Product Change Notification

Product Group: SFERNICE / February 14th 2019 / PCN-SF-227-2019 Rev 0 page 1/2

SFERNICE PRECISION POTENTIOMETERS 357 new laser Marking

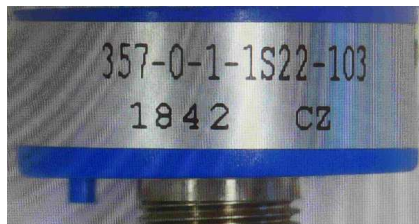
DESCRIPTION OF CHANGE: In line with our commitment for continuous improvement, Vishay Sfernice is implementing a new Marking for 357 precision potentiometers. Previous sticker marking was displaying a partial description, date code and pins positioning. New laser marked parts will show a complete SAP P/N (conform to Datasheet), date code and pins positioning.

Ex: “357-0-1-1S22-103 / 1842” becomes “357B0103MAB251S22 / 1842”
